Case number: H-15-077
Project Type: HDRB

PROJECT LOCATION (S): 829 West Manhattan Avenue

City of Santa Fe
Historic Districts Review Board
Findings of Fact and Conclusions of Law

Case #H-15-077B

PROPOSED SOUTH ELEVATION

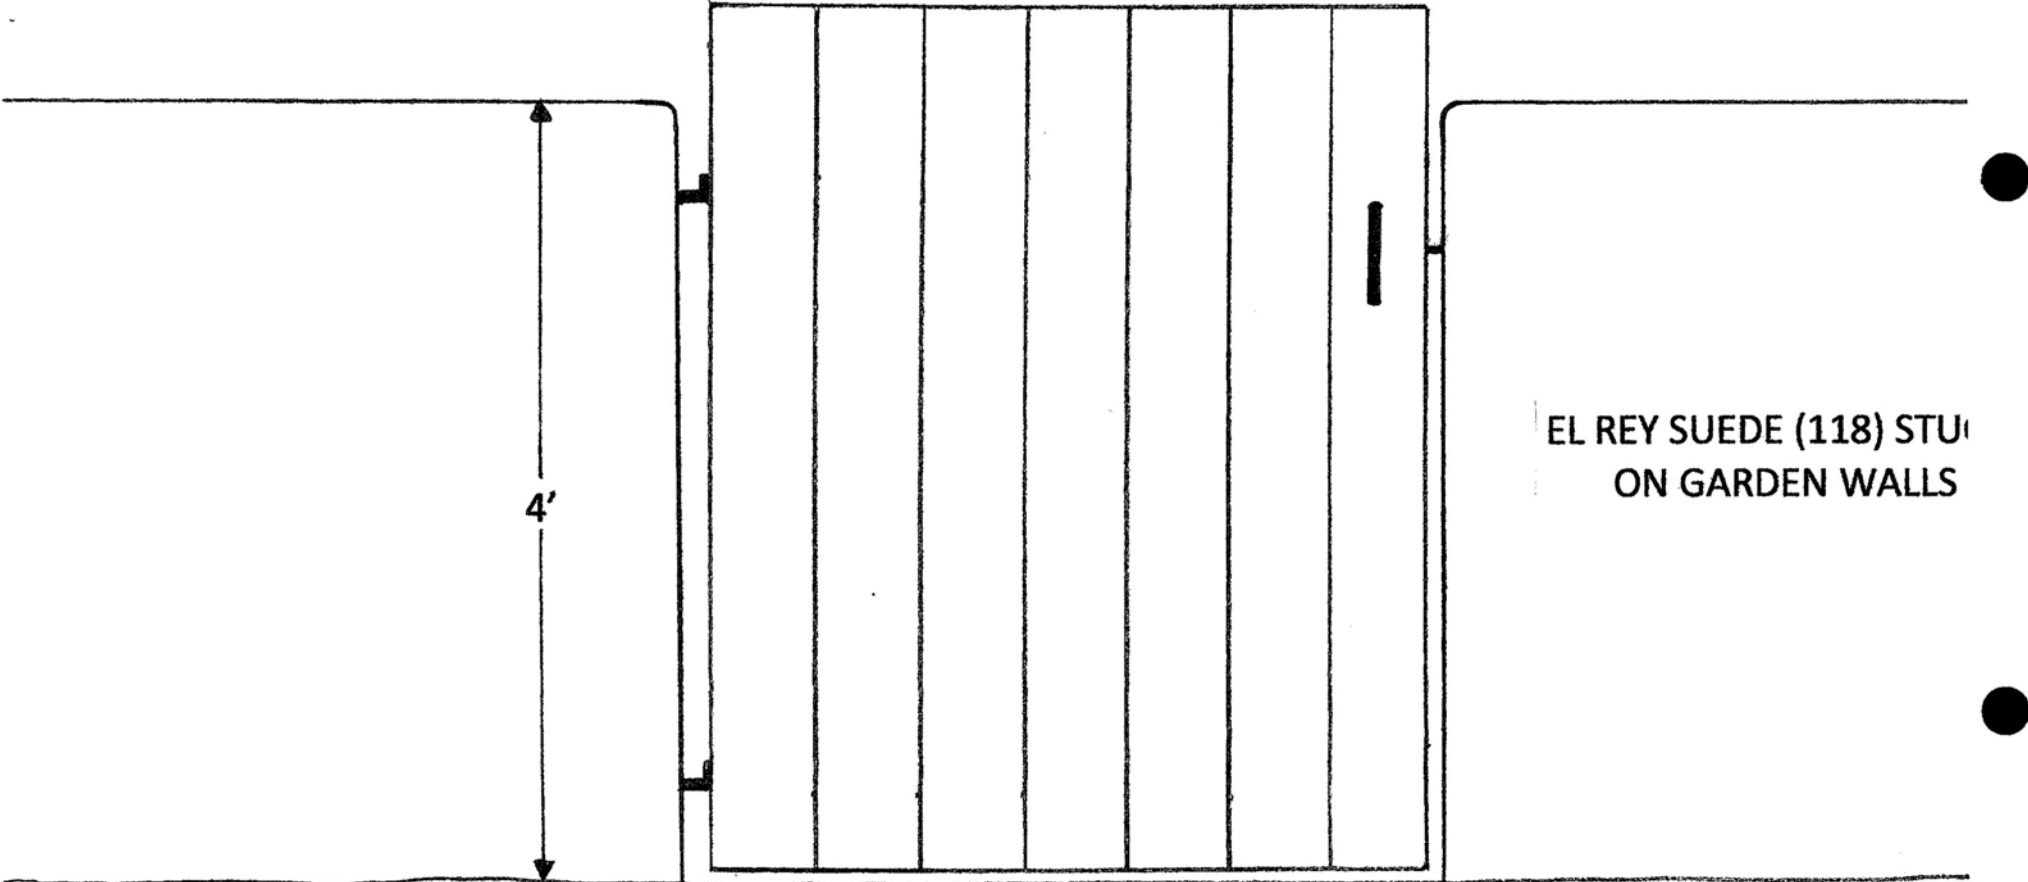
1. The Board has the authority to review and approve the Application.
2. The Board unanimously approved the Application as submitted.
 - X Additional Conditions, which are: that the new construction must be distinguished from old construction with a set off from the south elevation by at least 4 feet and set off from the west elevation by 3 feet; and that the new construction on the east elevation may be increased in size by 5 feet to the east.
